Access Compliance Report

Public Rights-of-Way

Intersection ID: 47978	Main Street: RAFFIA_RD	Cross Street: AVALY_LN	Location: NW
ADA ID: 88B6FF6C89C9	Ramp Type: PerpDiag	Initial Pass/Fail: Pass	Overall Compliance: No
		Severity Score: 5

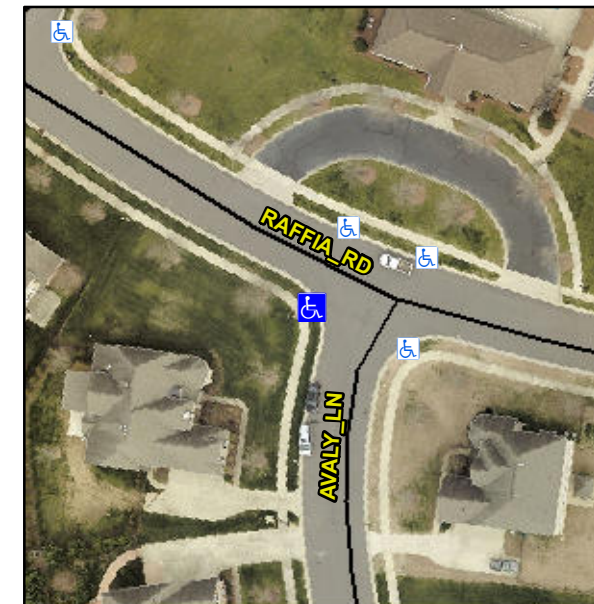
R304.5.3, R305.2, R304.5.4

Compliance	Description	Data	Compliance	Description	Data
N/A	Ramp Length (in)	70.0	Yes	Ramp Slope (%)	5.8
Yes	Ramp Width (in)	48.0	Yes	Ramp XSlope (%)	2.0
N/A	Flare Type LT	Sloped	N/A	Flare Type RT	N/A
N/A	Flare Slope LT (%)	3.7	Yes	Flare Slope RT (%)	7.2
N/A	Flare Traversable LT?	Yes	N/A	Flare Traversable RT?	Yes
Yes	Landing Length (in)	59.5	Yes	DWS Provided?	Yes
Yes	Landing Width (in)	48.0	Yes	DWS Contrast?	Yes
Yes	Landing Slope (%)	1.8	Yes	DWS Length (in)	24.5
No	Landing X Slope (%)	2.3	Yes	DWS Full Width?	Yes
N/A	Landing Curb? (Y/N)	No	No	DWS Offset (in)	4.0
N/A	Shared Landing?	No			
Yes	Gutter Ponding?	No	No	Gutter Slope (%)	8.3
Yes	Gutter Lip Ht (in)	0.0	Yes	Gutter X Slope (%)	2.0
N/A	Painted X Walk1?	No	N/A	Painted X Walk2?	No
	X Walk 1 Direction	To SE		X Walk 2 Direction	To NE
N/A	X Walk 1 Width (in)	N/A	N/A	X Walk 2 Width (in)	N/A
	X Walk 1 Slope (%)	2.3		X Walk 2 Slope (%)	1.7
	X Walk 1 X Slope (%)	3.3		X Walk 2 X Slope (%)	0.8

Remove & Replace Curb Ramp With Two New Directional Ramps or Equivalent. Remove & Replace Gutter.
